Smith Ranch - Highland
Uranium Project
P.O. Box 1210
Glenrock, Wyoming USA 82637
Casper: 307-235-1628
Douglas: 307-358-6541
Fax: 307-358-4333

RE: Permit to Mine 603
A-Wellfield Long-Term Ground Water Monitor Plan

RE: Permit to Mine 603
A-Wellfield Revised Long-Term Ground Water Monitoring Plan

A-Wellfield Long-Term Monitor Location

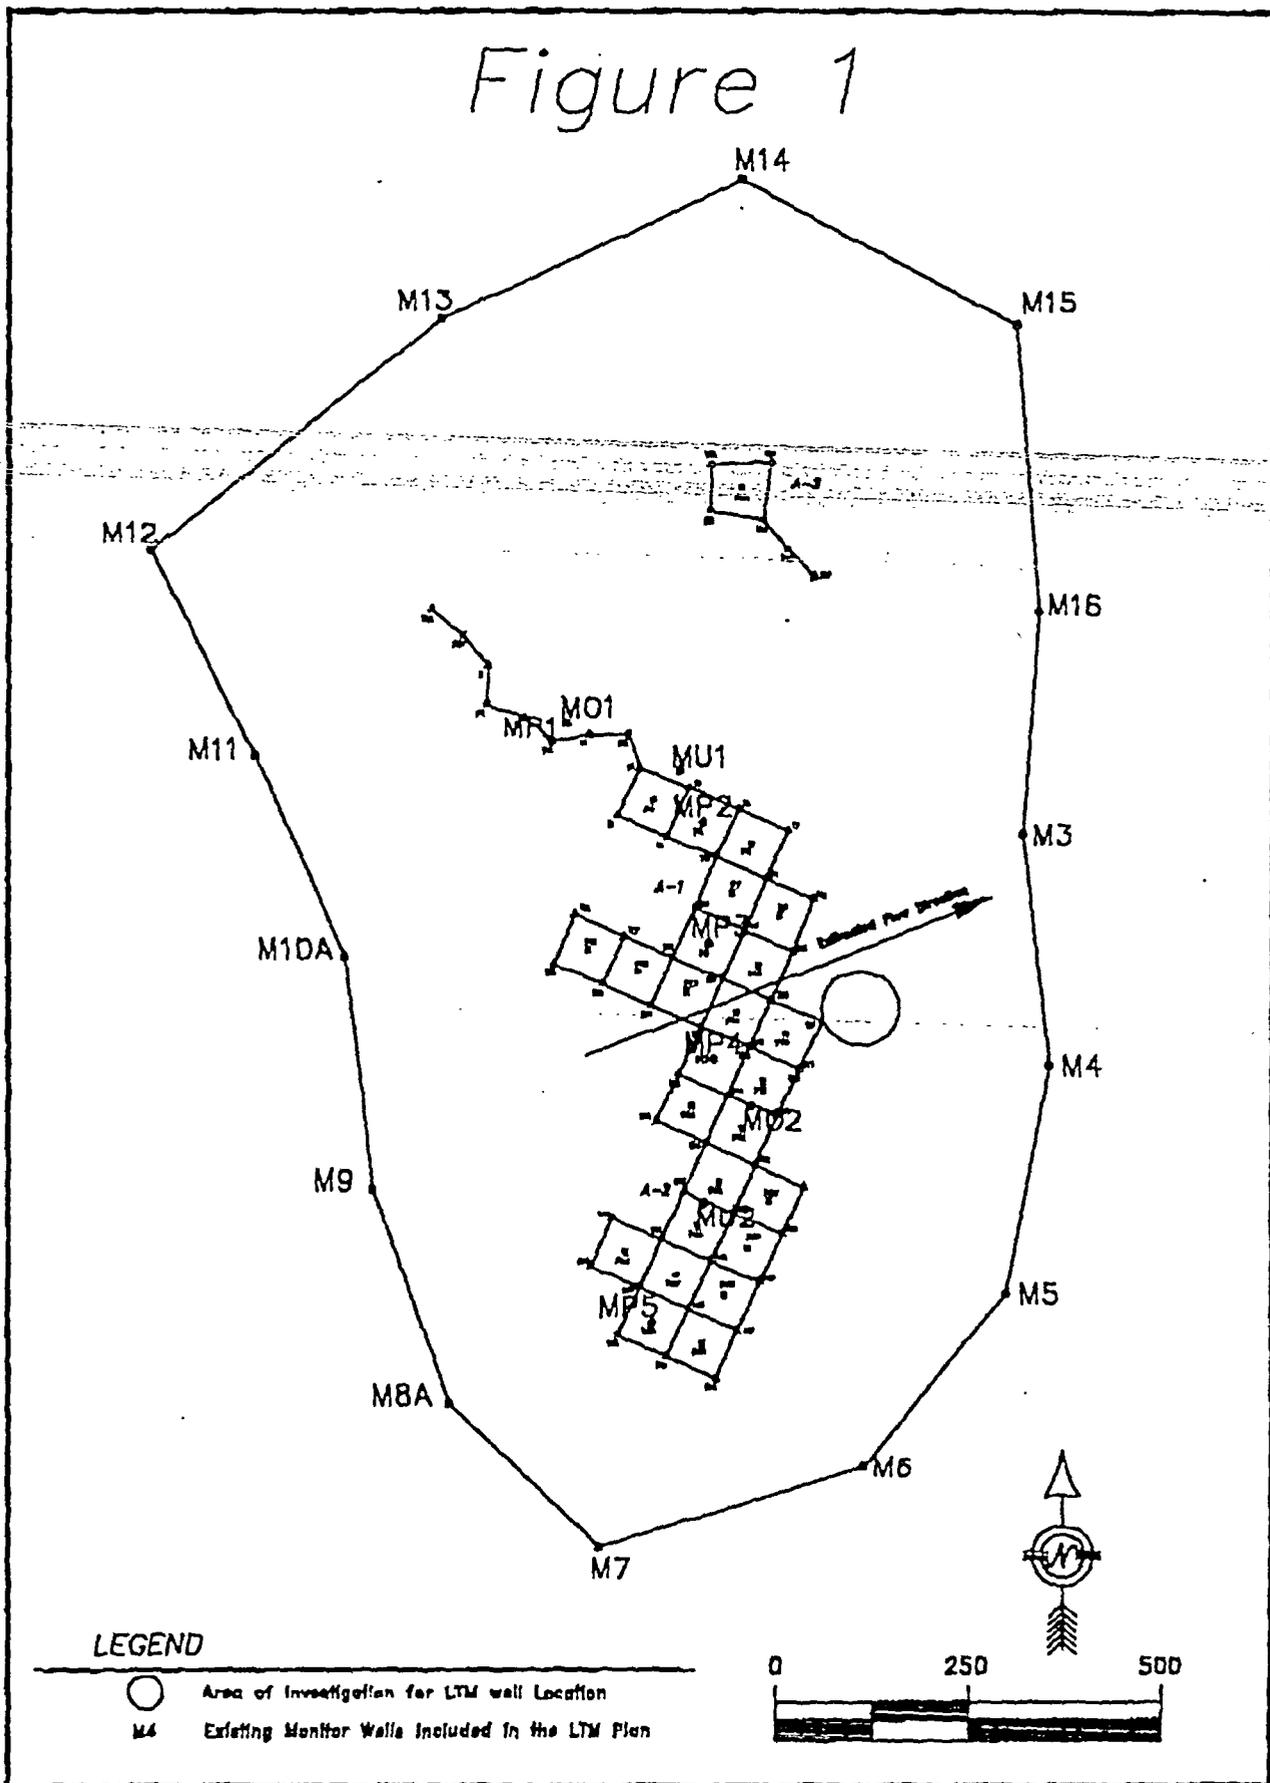
To determine the location of the new monitor well, PRI will first attempt to identify the extent of lateral flaring of mining solutions, which occurred during mining in the 20-Sand downgradient of the A-Wellfield. This is important since the restored ground water must be monitored as it moves through a geochemically reduced environment as opposed to the potentially slightly oxidized zone of flaring. Once this is accomplished, a LTM Well will be located and completed in the appropriate zone to monitor the restored ground water as it migrates away from the wellfield. This well will be located downgradient of a mining well (historic Production or Injection Well) that has been sampled for the constituents of concern. Figure 1 shows the area that is being considered for the LTM Well.

PRI will utilize three wells already in use as monitoring wells to track changes in the 20-Sand ground water quality over time and distance (see Figure 1). Well MP-3 will track the changes within the wellfield as up gradient ground water flushes the restored wellfield area. Wells M-3 and M-4 will be used to detect any changes to the downgradient conditions that may potentially decrease the effectiveness of the natural attenuation process. Also, water level data, collected from all four wells will be used to determine the ground water gradient and flow rate in the 20-Sand.

A-Wellfield Long-Term Monitor Location

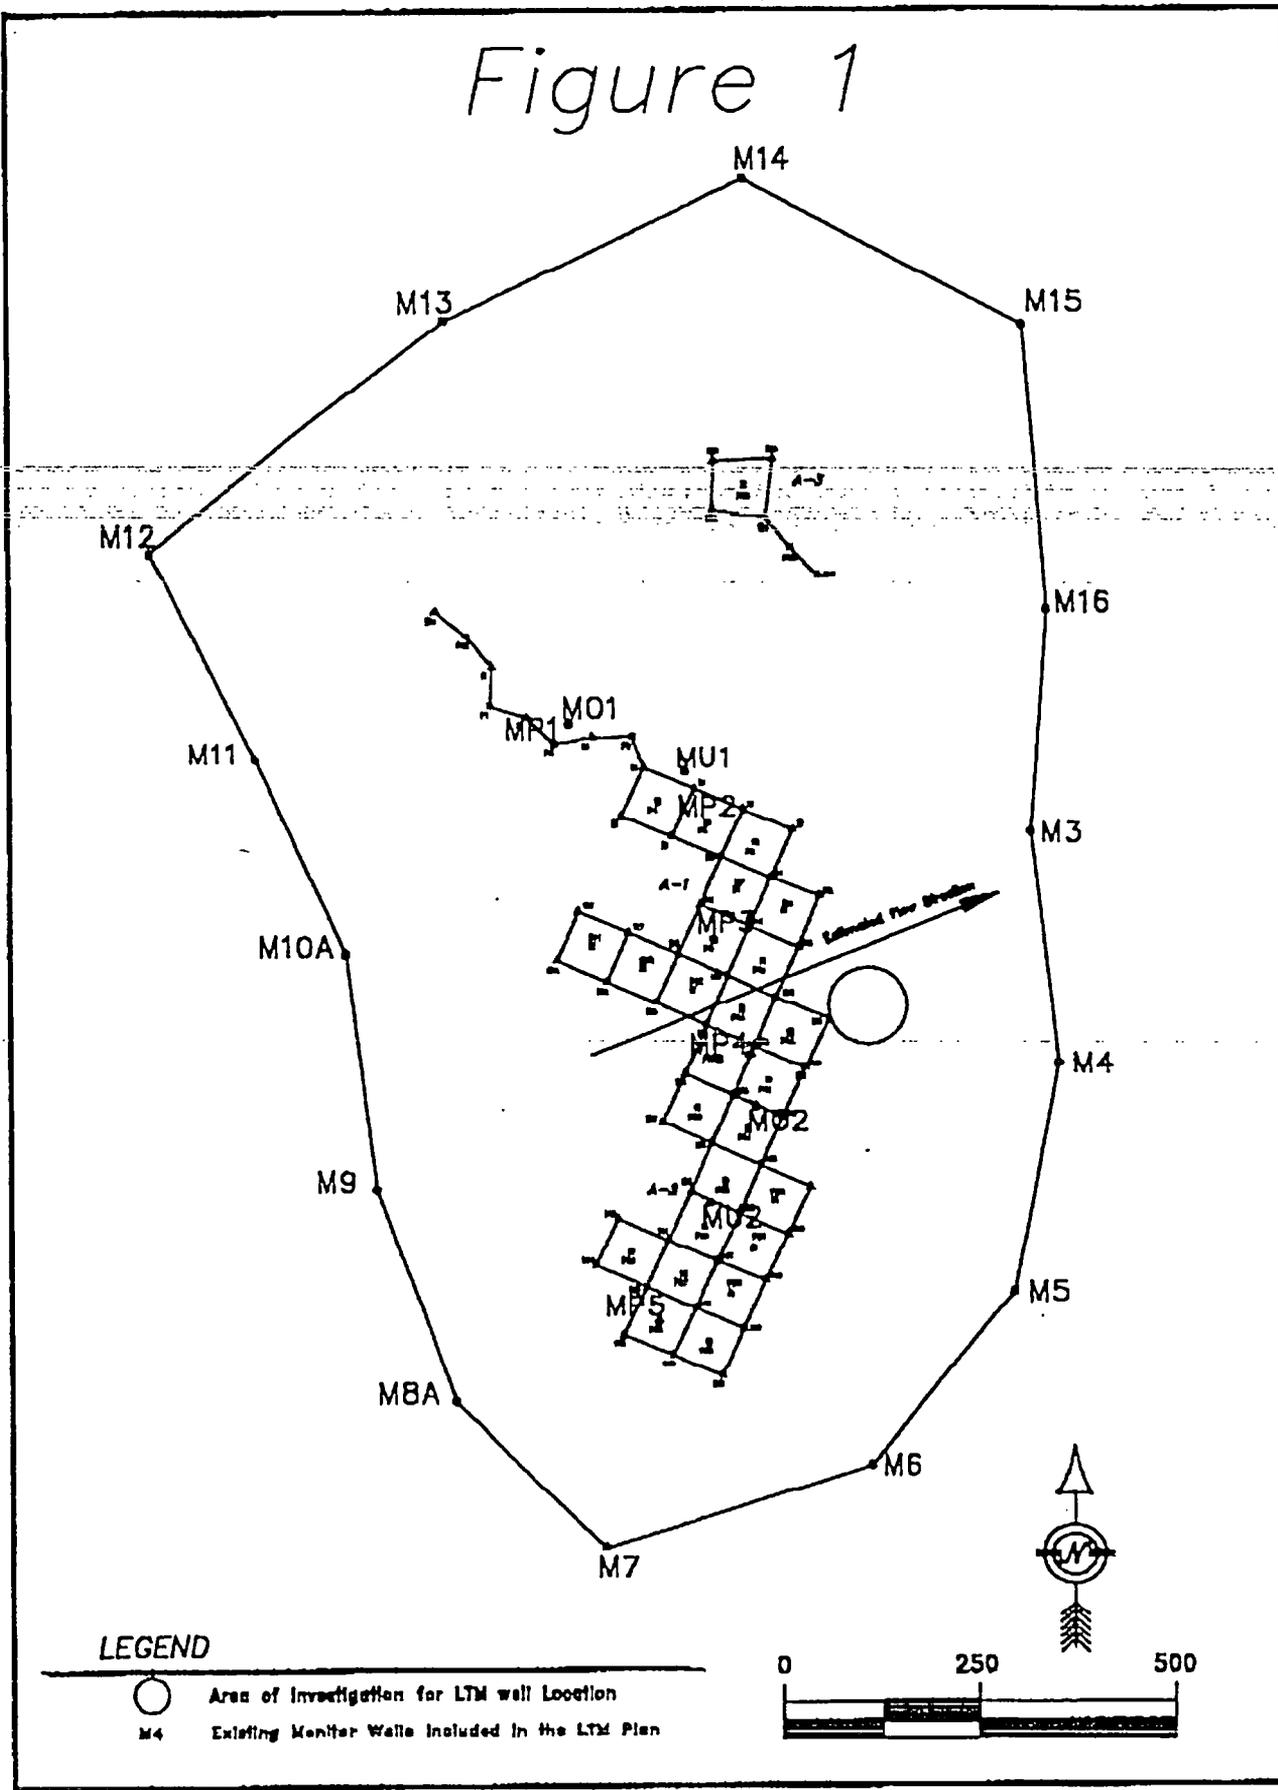
PRI accepts Mr. Ingle's first proposed modification to monitor Well MP-4 instead of Well MP-3.

In reference to Mr. Ingle's second proposed modification, PRI agrees to add an additional well to the LTM plan located on the oxidized side of the redox interface downgradient of the A-Wellfield. PRI believes that by adding an additional well closer to the wellfield edge, the duration of the LTM Plan may be decreased.

To determine the locations of the two new monitor wells, PRI will identify the extent of lateral flaring of mining solutions, which occurred during mining in the 20-Sand downgradient of the A-Wellfield. This is important since the restored ground water must be monitored as it moves through a geochemically reduced environment as opposed to the potentially slightly oxidized zone of flaring. Once this is accomplished, two LTM Wells will be located and completed in the appropriate zone to monitor the restored ground water as it migrates away from the wellfield. One of the new LTM Wells will be located within the zone of flaring, while the second LTM Well will be located downgradient in an area unaffected by mining solutions. These wells will be located northeast of a mining well (historic Production or Injection Well) that has been sampled for the constituents of concern. Figure 1 shows the area that is being considered for these LTM Wells.

PRI will utilize three wells already in use as monitoring wells to track changes in the 20-Sand ground water quality over time and distance (see Figure 1). Well MP-4 will track the changes within the wellfield as up gradient ground water flushes the restored wellfield area. Wells M-3 and M-4 will be used to detect any changes to the downgradient conditions that may potentially decrease the effectiveness of the natural attenuation process. Also, water level data, collected from all five wells will be used to determine the ground water gradient and flow rate in the 20-Sand.
